# Access Compliance Report

## Public Rights-of-Way (Curb Ramps)

Intersection ID: 51379	Main Street: BROADRICK_BV	Cross Street: UNIVERSITY_CITY_BV	Location:	S
ADA ID: BEF3E8F820AA	Ramp Type: Directional1	Initial Pass/Fail: Pass	Overall Compliance: No	Severity Score: 0

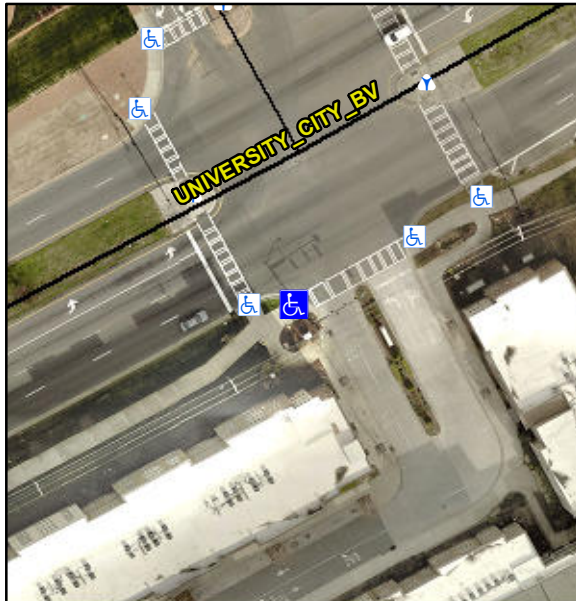
**R304.2.2-Perp, R304.3.2-Para,  
R304.5.3**

Compliance	Description	Data	Compliance	Description	Data
N/A	Ramp Length (in)	101.0	N/A	Grade Break?	N/A
Yes	Ramp Width (in)	117.5	N/A	Grade Break Slope (%)	2.5
Yes	Ramp Slope (%)	1.4	N/A	Grade Break XSlope (%)	0.5
Yes	Ramp XSlope (%)	0.9			
Yes	Flare Type LT	N/A	Yes	Flare Type RT	N/A
N/A	Flare Slope LT (%)	N/A	N/A	Flare Slope RT (%)	N/A
N/A	Flare Traversable LT?	No	N/A	Flare Traversable RT?	No
Yes	Landing Length (in)	99.0	Yes	DWS Provided?	Yes
Yes	Landing Width (in)	118.0	Yes	DWS Contrast?	Yes
No	Landing Slope (%)	2.8	Yes	DWS Length (in)	24.0
No	Landing X Slope (%)	2.5	Yes	DWS Full Width?	Yes
N/A	Landing Curb? (Y/N)	No	Yes	DWS Offset LT (in)	54.0
N/A	Shared Landing?	No	Yes	DWS Offset RT (in)	0.0
Yes	Gutter Ponding?	No	Yes	Gutter Slope (%)	2.0
Yes	Gutter Lip Ht (in)	0.0	No	Gutter X Slope (%)	2.5
N/A	Painted X Walk1?	Yes		Road Slope (%)	2.1
	X Walk 1 Direction	To NE		Road X Slope (%)	1.3
	X Walk 1 Width (in)	106.0		Clear Space?	Yes

X Walk 1 Slope (%)	2.1	N/A	Clear Space to XWalk (in)	N/A
	X Walk 1 X Slope (%)	1.3	Yes	Storm Grate/Utility Hazard?	No
Yes	Ramp inside XWalk1?	Yes		Storm Grate/Utility Type	
Yes	Any Obstructions?	No			N/A
	Obstruction Type		Yes	Surface Condition? (G/P)	Good
			N/A	Curb Slope (%)	2.5

**Remove & Replace Landing.  
Remove & Replace Gutter.**
